RESOLUTION NO. R16-94

**A RESOLUTION AUTHORIZING THE MAYOR TO SIGN
CHANGE ORDER NO. 1 WITH WILSON BROTHERS CONSTRUCTION
FOR THE WATER TREATMENT PLANT INTAKE PROJECT
CONSTITUTING A DECREASE OF \$3,217.12.**

| Project: | Water Treatment Plant Intake | Contract Name: | N/A |

The Contract is modified as follows upon execution of this Change Order:

SHEET NO.
P18
27 OF 74

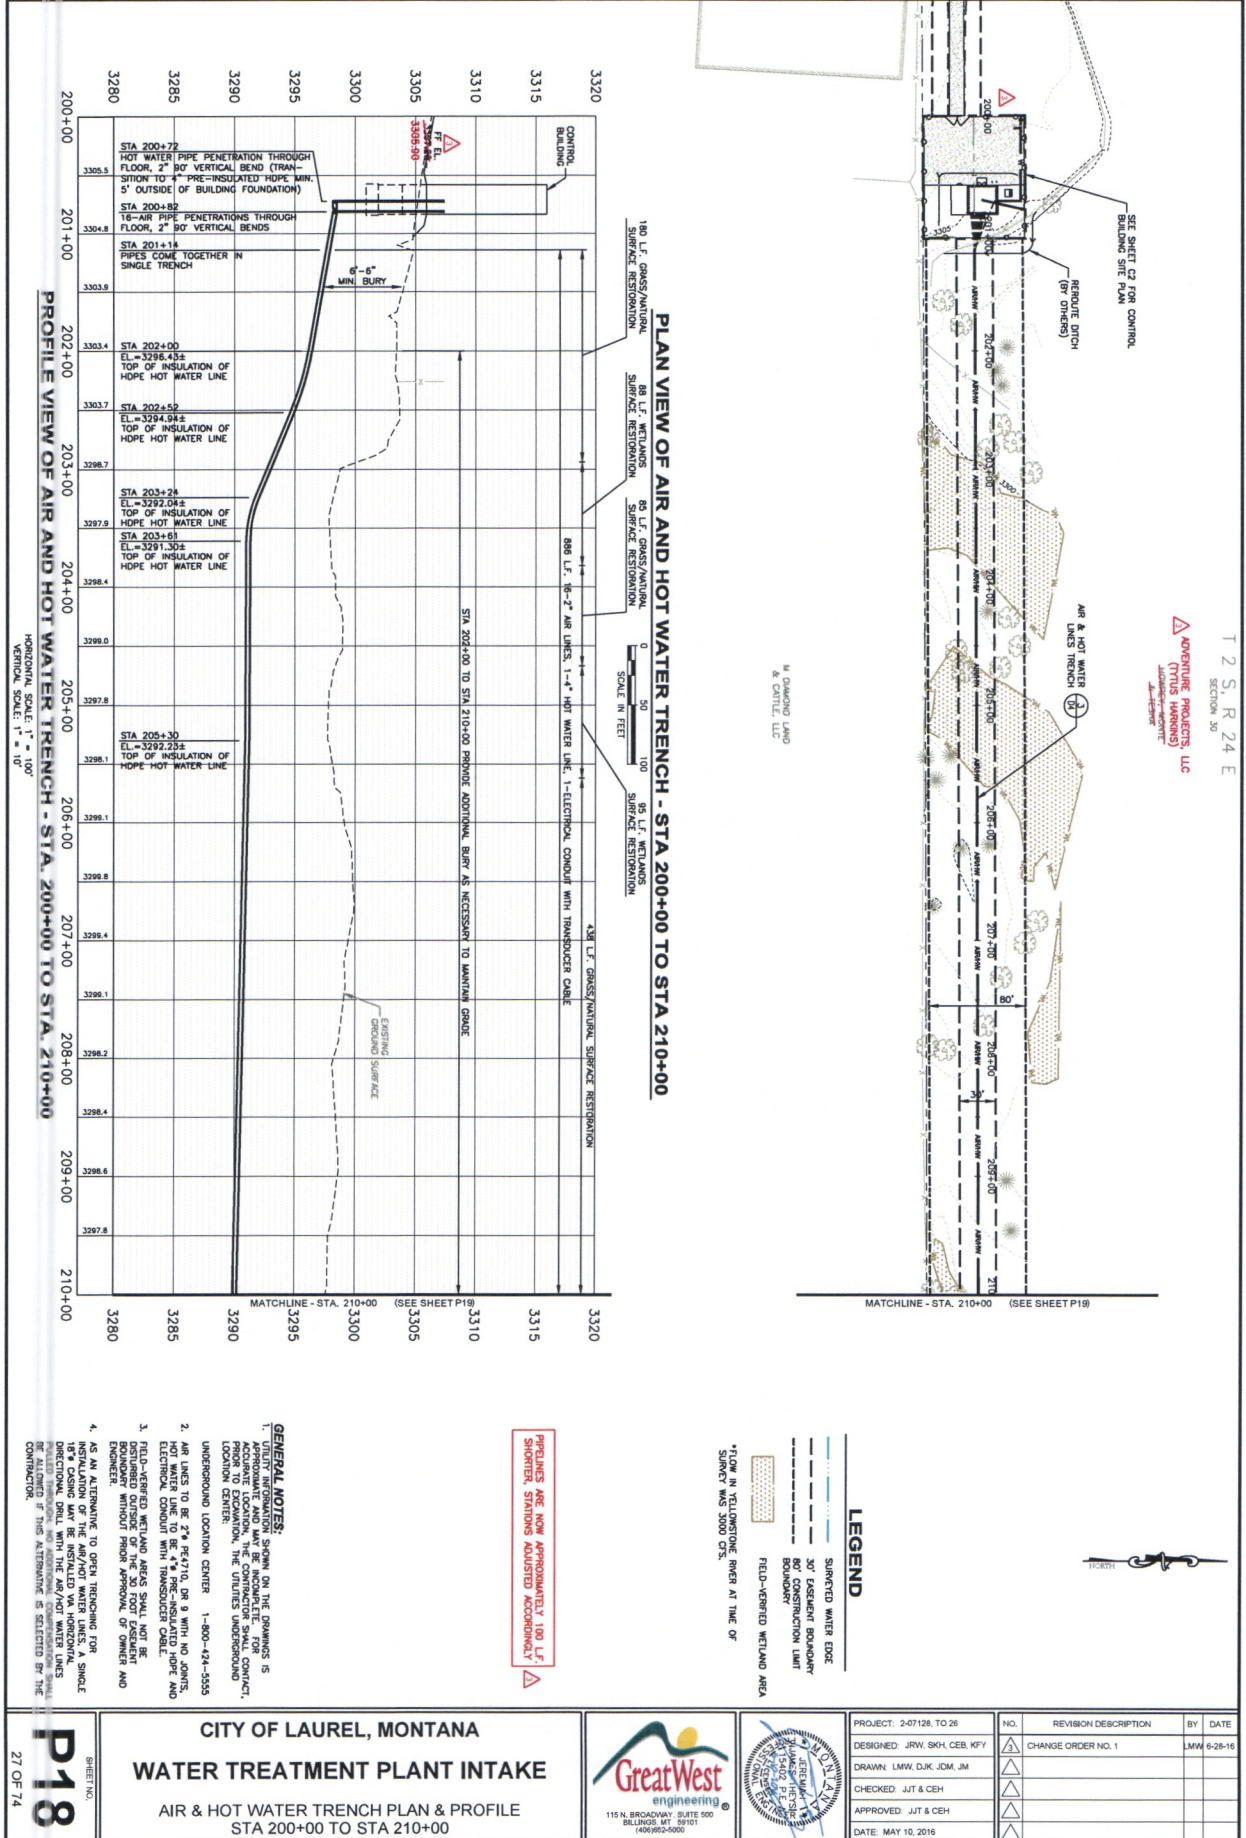
The following changes are a result of the shift in the control building site approximately 108 feet to the east, lengthening the access road to the west and shortening the pipelines to the east.

- The contract quantity for *Item No. 317 – 2" Diameter Air Purge Line from Control Building to Intake* will be decreased from 39,520 LF to 37,792 LF. Decrease in cost = 1,728 LF x \$2/LF = (\$3,456).

- The contract quantity from *Item No. 320 – 4" Pre-Insulated Hot Water Line from Control Building to Intake* will be decreased from 2,470 LF to 2,362 LF. Decrease in cost = 108 LF x \$45/LF = (\$4,860).

SHEET NO.
P19
28 OF 74

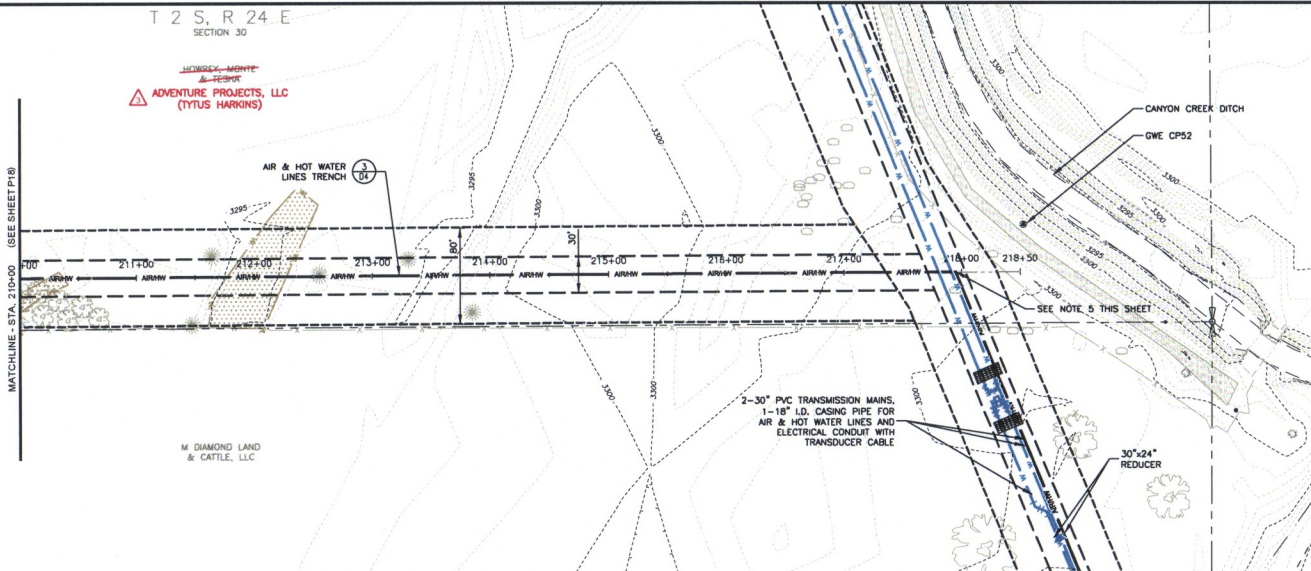
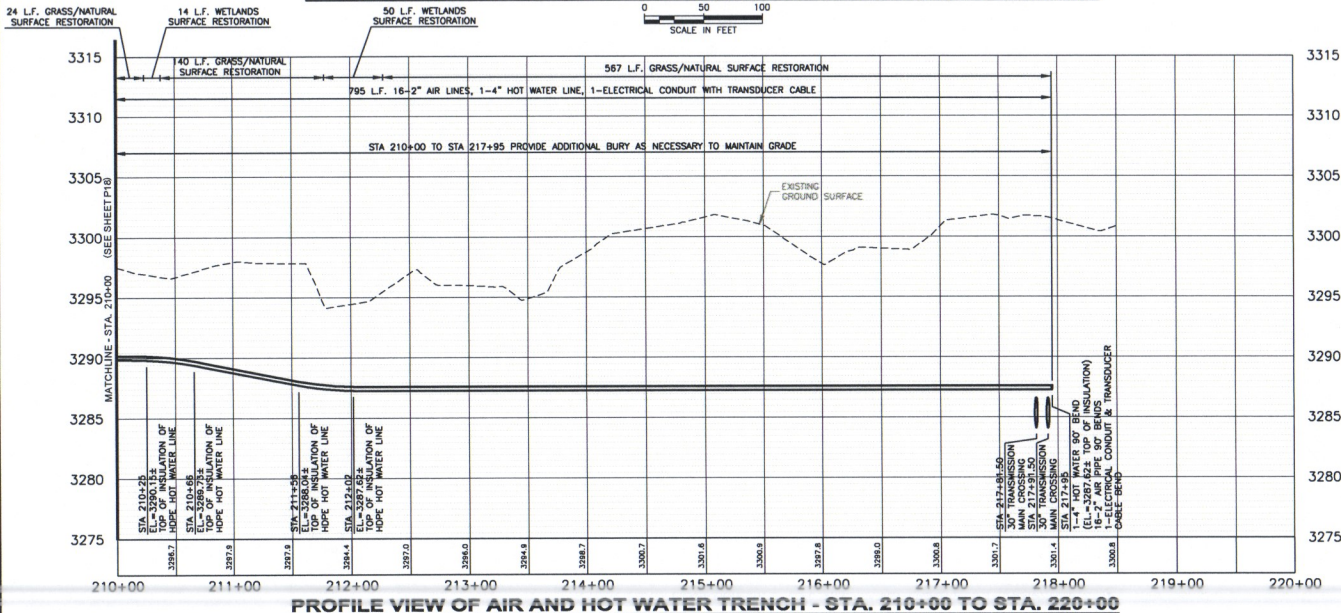
PIPELINES ARE NOW APPROXIMATELY 100 L.F. SHORTER, STATIONS ADJUSTED ACCORDINGLY
